Final DRAFT

Memorandum

From: The Wiehle Avenue Pedestrian Crossing Study Group (Study Group)

Re: Results of the Study Group Findings

Sunrise Valley ‘T’ Intersection Details:

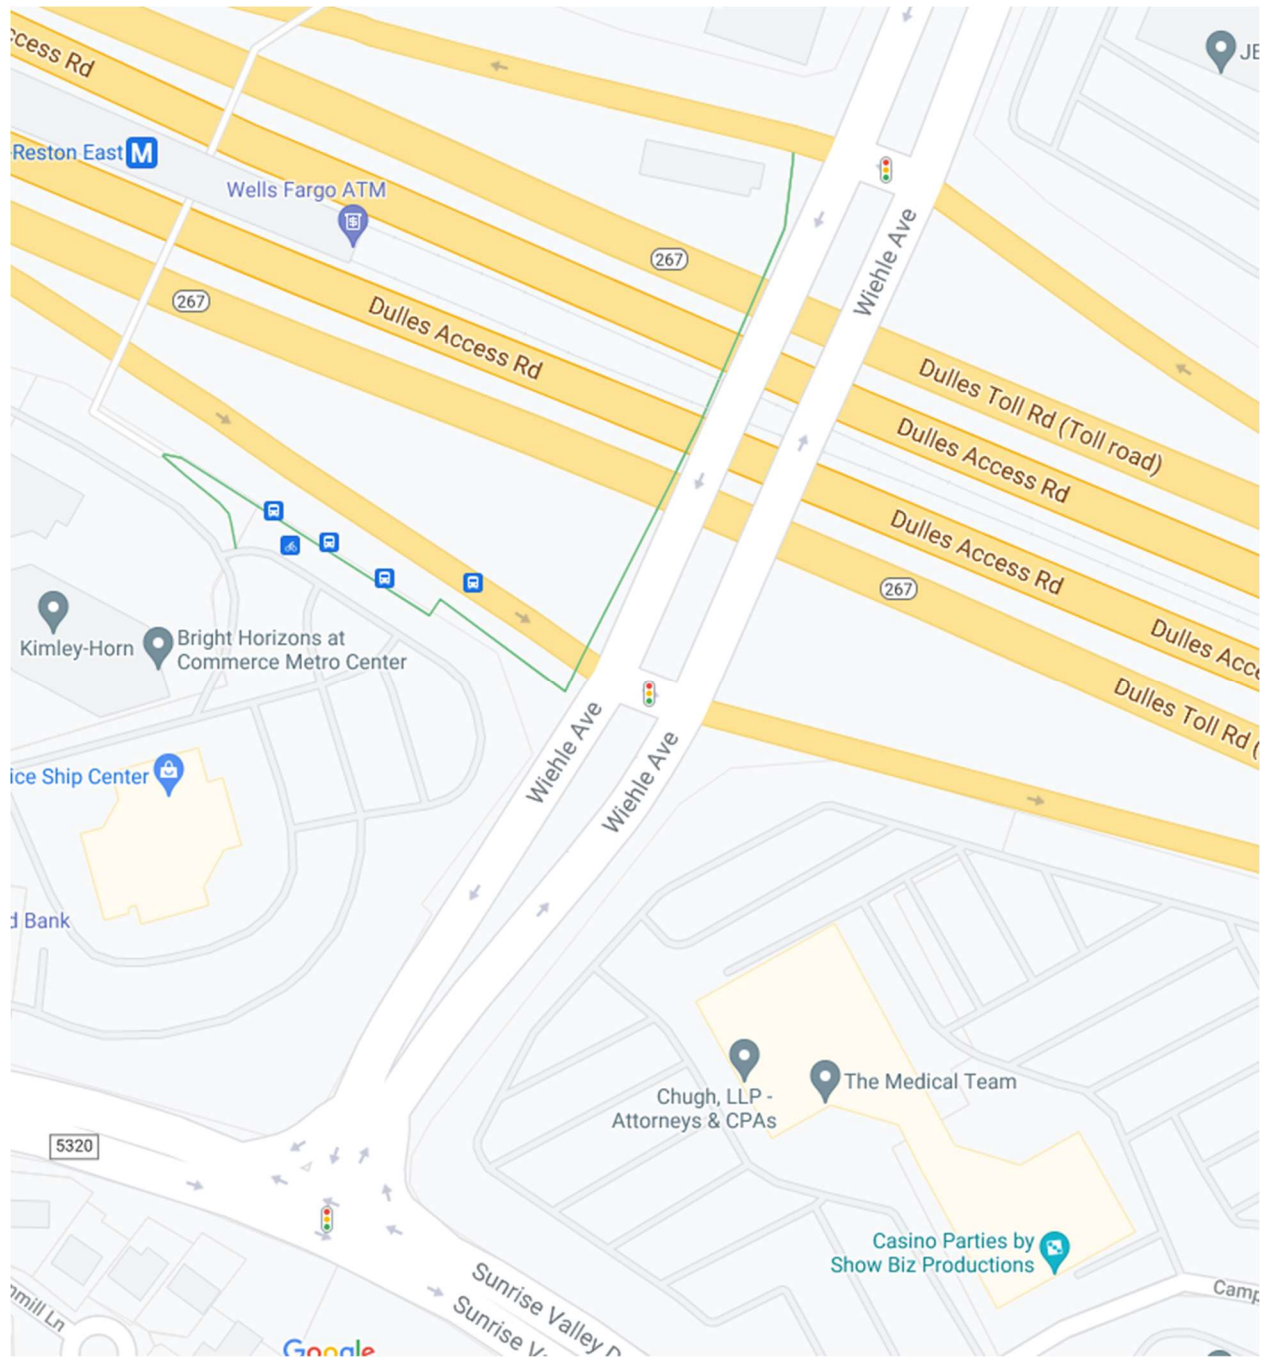
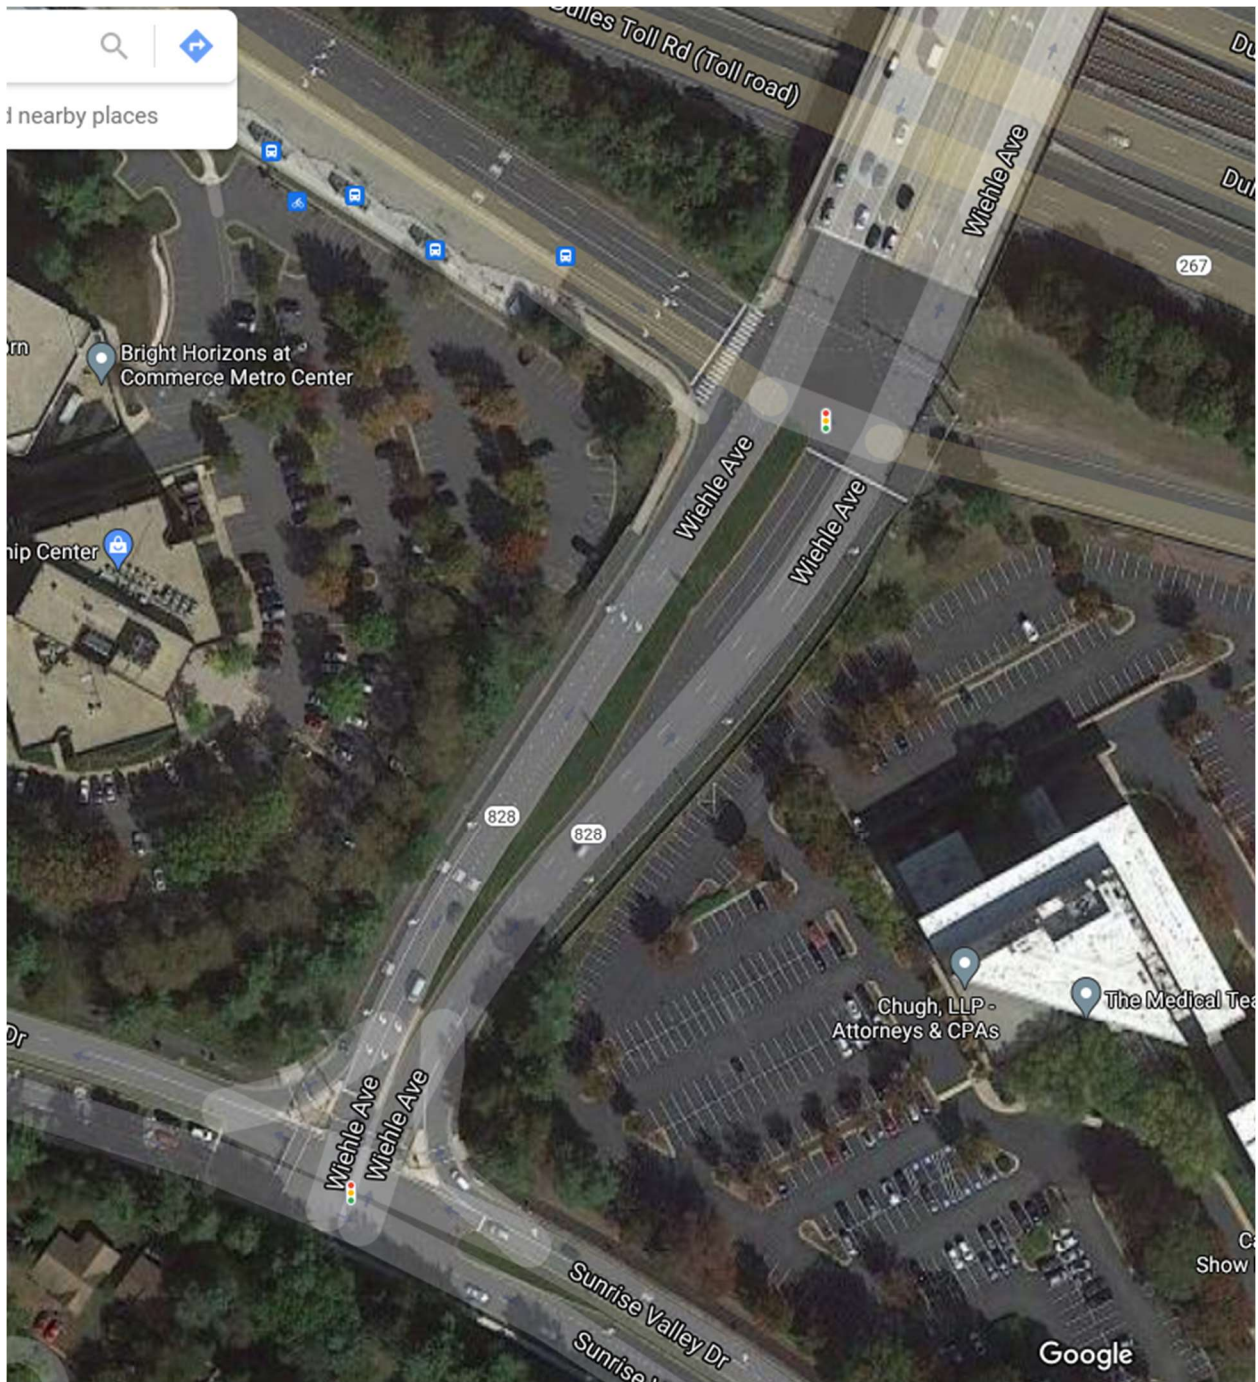
- 5. Reduce vehicular curb turn radii to slow down traffic.
- 6. For south-bound Wiehle traffic, eliminate continuous right turn option and emphasize **FULL STOP** for vehicular/cycle traffic turning west-bound onto Sunrise Valley.

- 7. Consider blinking red during late night/early morning hours of light multi-modal usage at this intersection.
- 8. **Provide N/S pedestrian crossing ONLY at west side of Sunrise Valley T due to huge demand on Sunrise of vehicles to access Wiehle Bridge and complex stoplight timing challenges.**

- b. Reconsider adding east side pedestrian crossing with accompanying north-bound sidewalk to this T intersection **ONLY** when East side pedestrian and cycle track bridge across DTR is provided.

9. Provide simple E/W pedestrian/cycle track crosswalk at junction of Wiehle/Sunrise governed by stop light with no porkchops. Continue color codes as appropriate to promote predictability in this crosswalk.
10. Designated colors for peds/cycle lanes continue onto Sunrise so that users stay in appropriate lanes for safety/predictability.

Appendix 4- Rob Walker's Road Diet and Crosswalk Concept

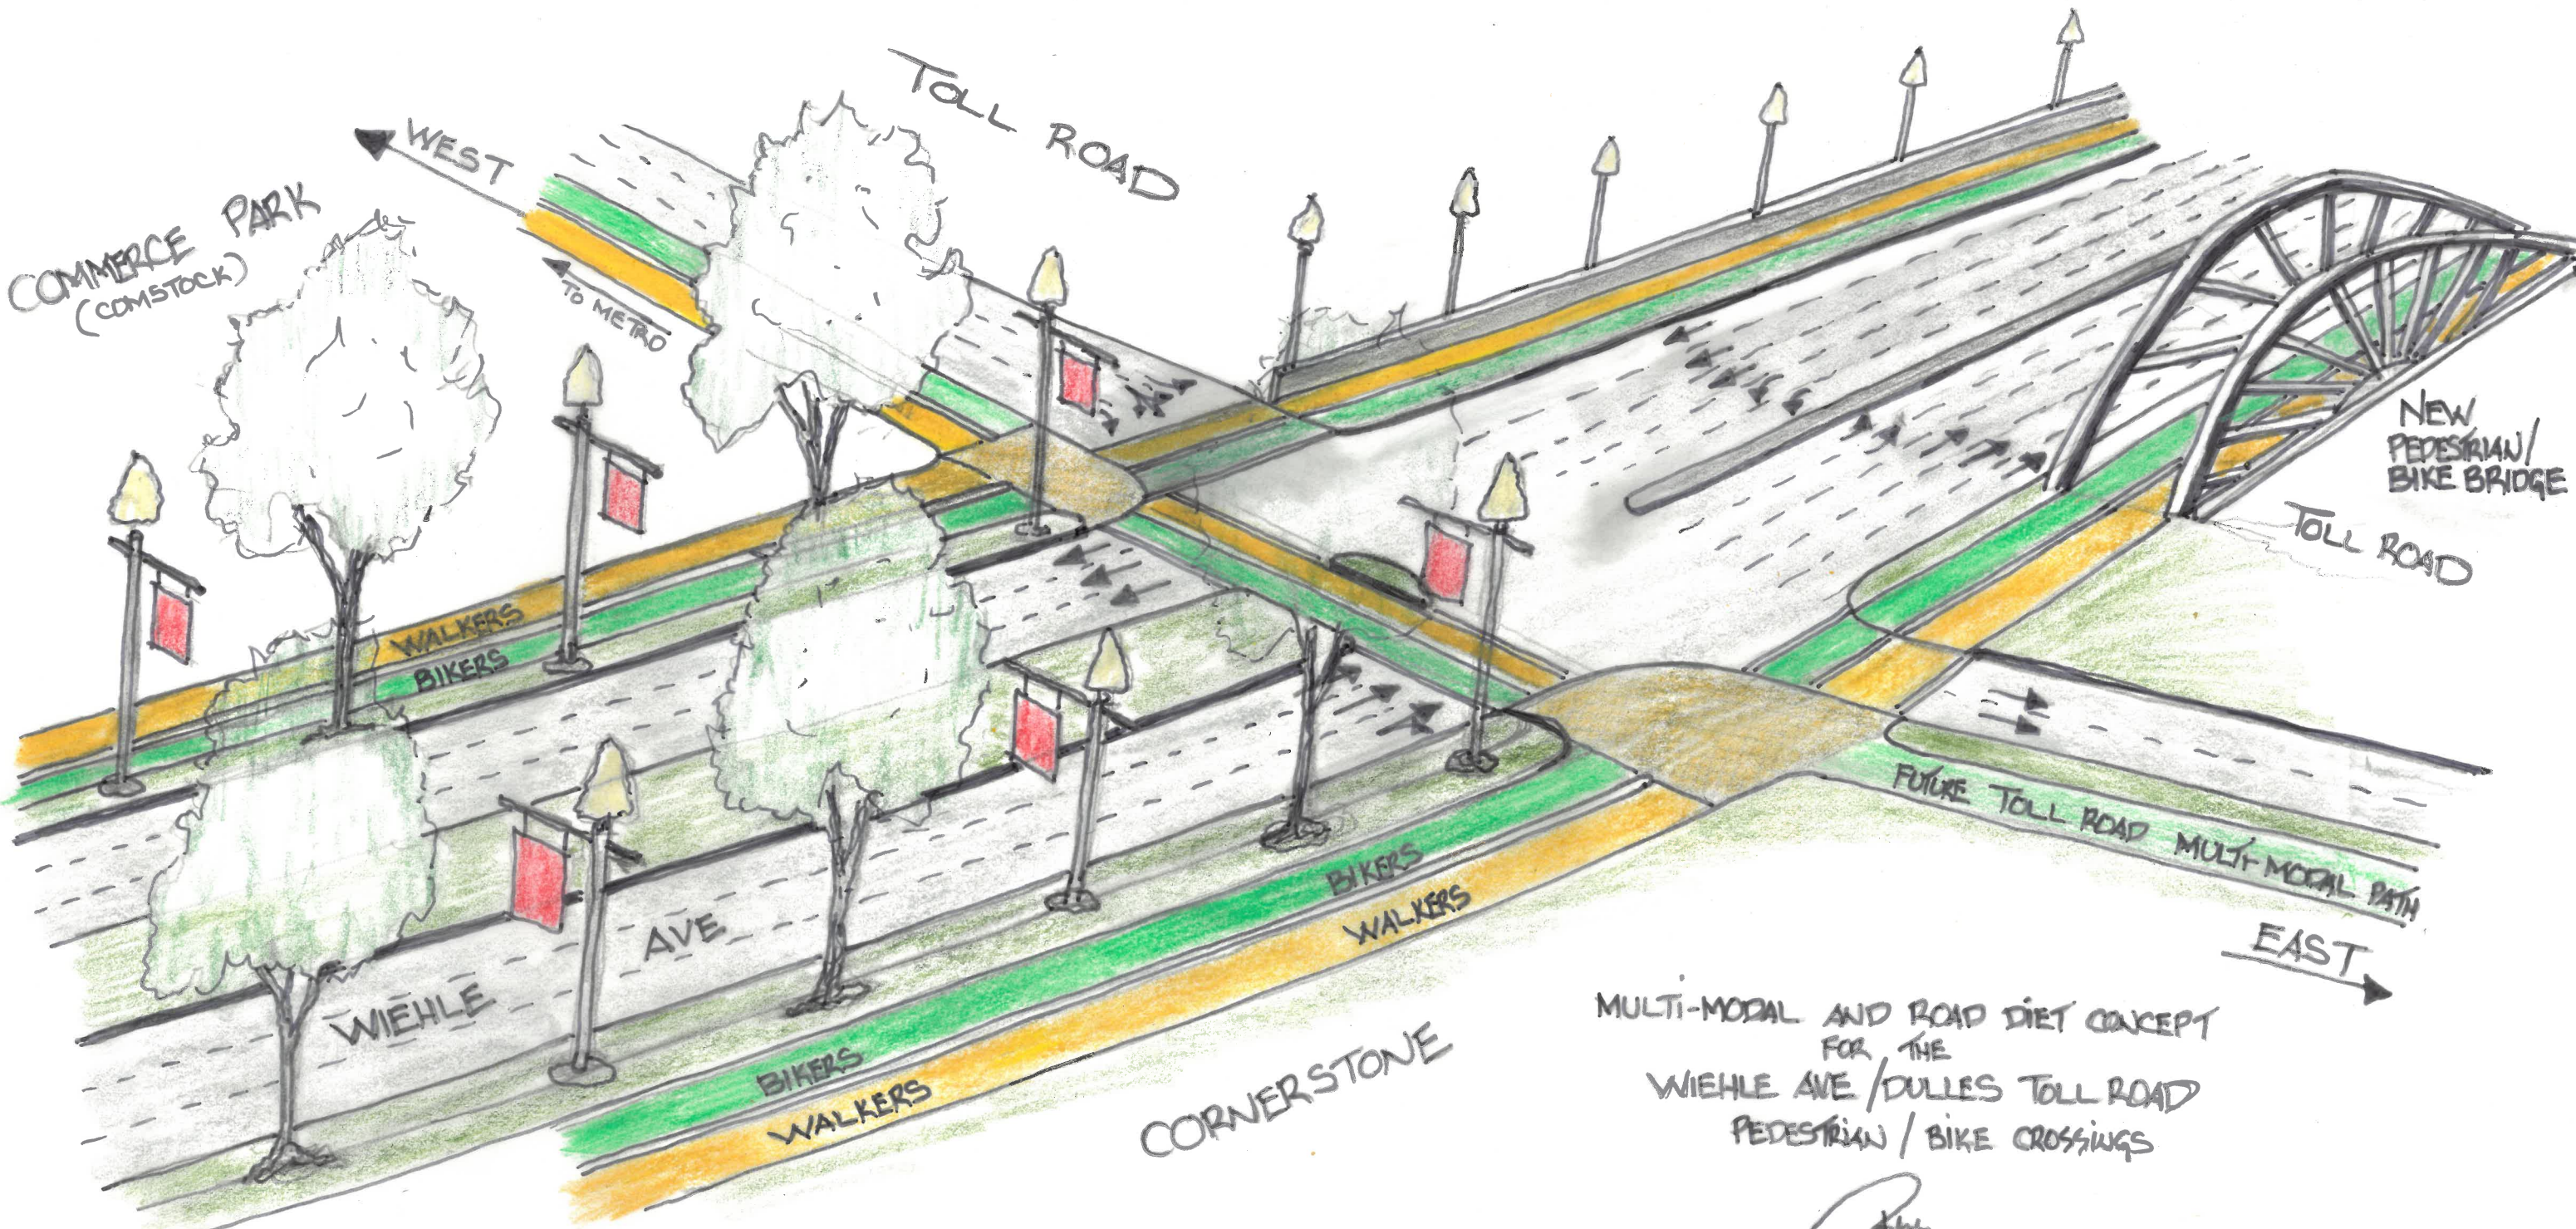
ROB WALKER (Reston resident and Chairman of the Reston P&Z Committee) – Prefers enhanced streetscapes, narrow traffic lanes, and a multimodal approach to slow traffic. He proposes the removal of the ex. free- flow vehicular movements and create safe at-grade crossings at both the Dulles Toll Road and at Sunrise Valley Drive as well as other crossings further north along Wiehle Ave. He does not believe any of the bridge options are a good idea and believes the tunnel is too expensive and would not help to address the future north /south pedestrian and bike traffic.

(See enclosed Appendix 4 for Rob's example of an at-grade enhanced at-grade pedestrian crossing)

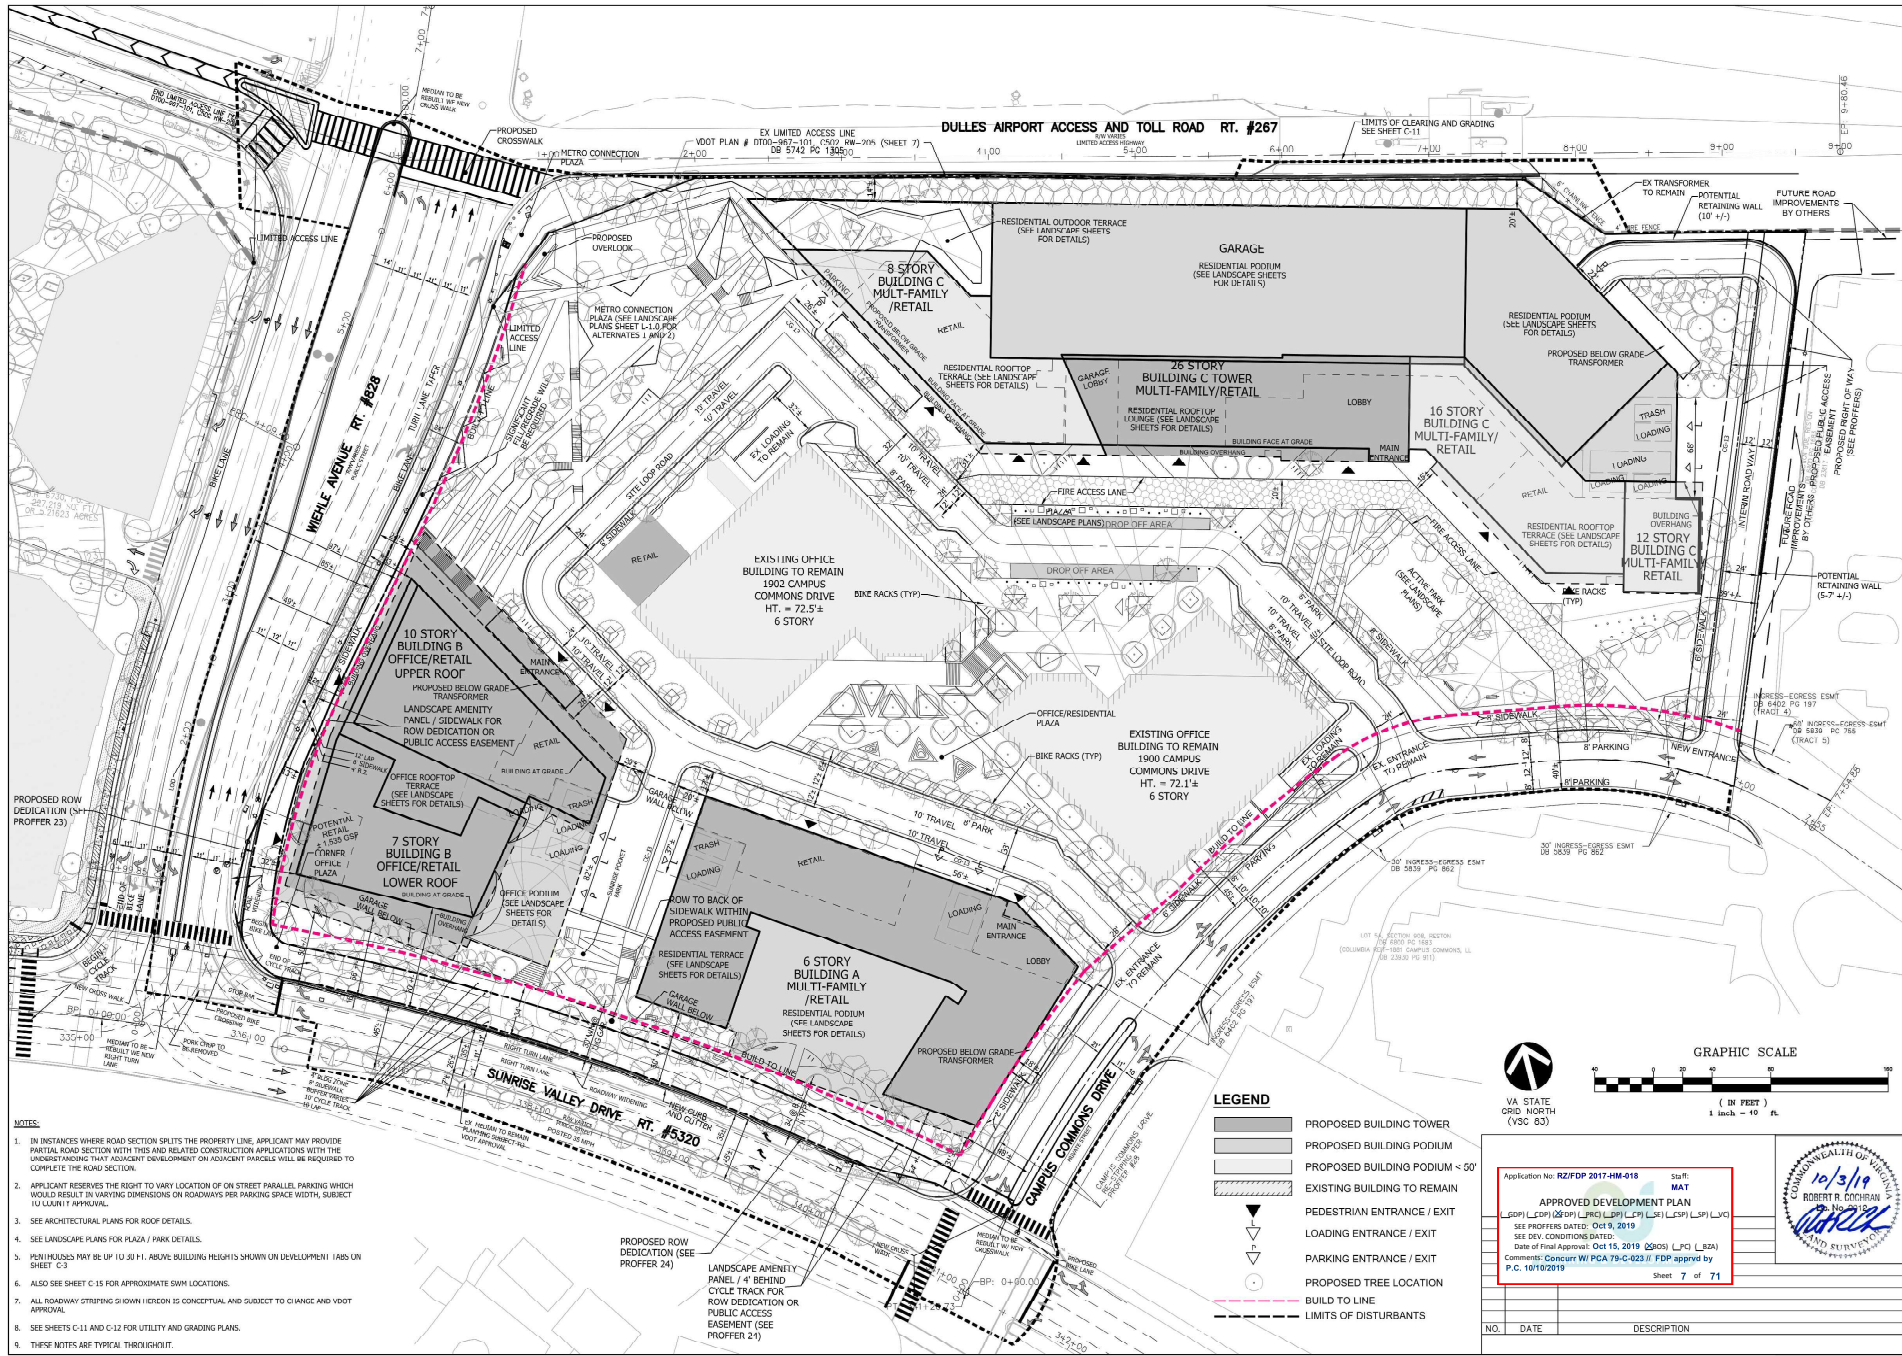
1. Based on the comments below, the Study Group does not support the at-grade crosswalk across Wiehle Ave at the Dulles Toll Road as shown in the CDP/FDP on Sheet C-07. (See Appendix #5.)
